1132A-01B

# S E R V I C E N O T E

## 1132A Infiniimax Probe Amplifier 5GHz

**Possible fractured solder joint on input pin**

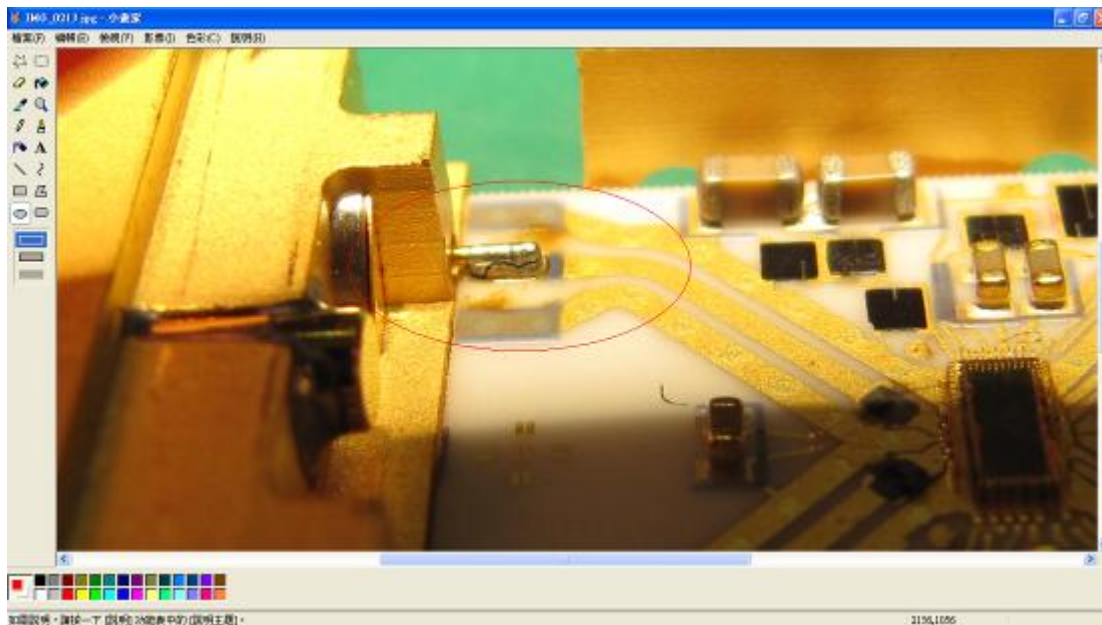
There is a possibility that the input pin solder joint may be fractured. You may also find the input pin bent, broken off, or stuck into the female connector of a probe head.

The above picture shows a fractured solder joint.

The above picture shows where the long pin of the probe amplifier actually got stuck in the female connector of the probe head. When the probe head was removed from the probe amp, part of the probe head female connector stuck to the probe amplifier pin and was pulled out.

5. If you determine that the solder joint is fractured, bent, broken, or probe head parts stuck to a probe pin, replace with a new 01132-68701 probe amplifier. Charge the replacement cost to factory warranty.

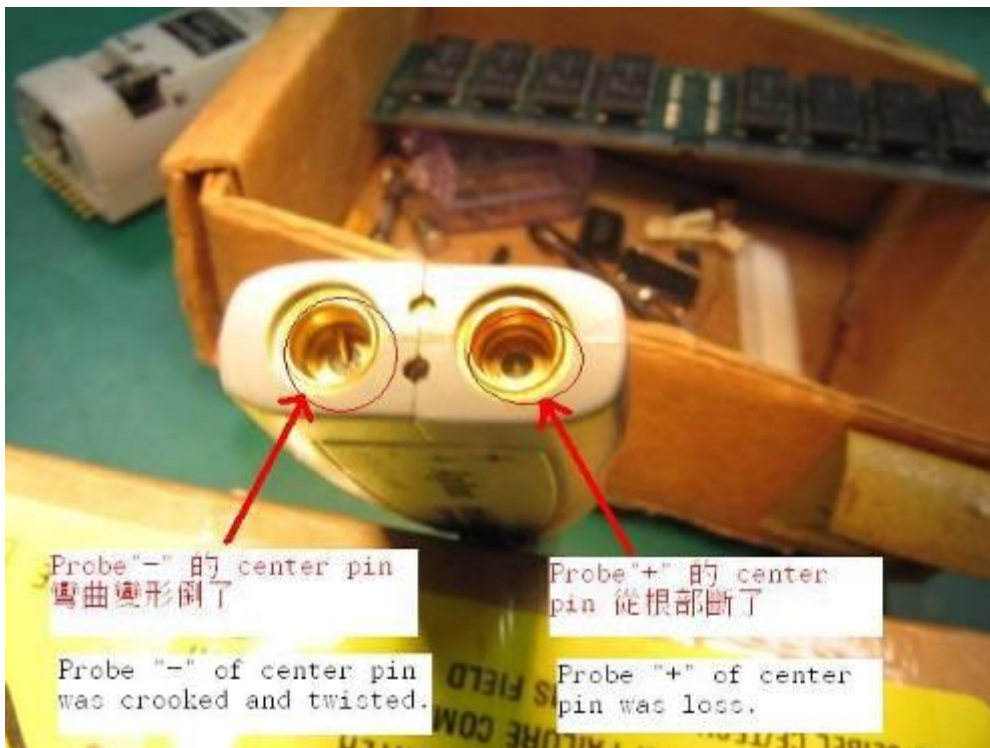
The above picture shows a bent male pin and a broken male pin. The longer male pin could cause the pin to bend or eventually break when connected to a probe head.

If you find the above mechanical defects, replace with a new 01132-68701 probe amplifier.
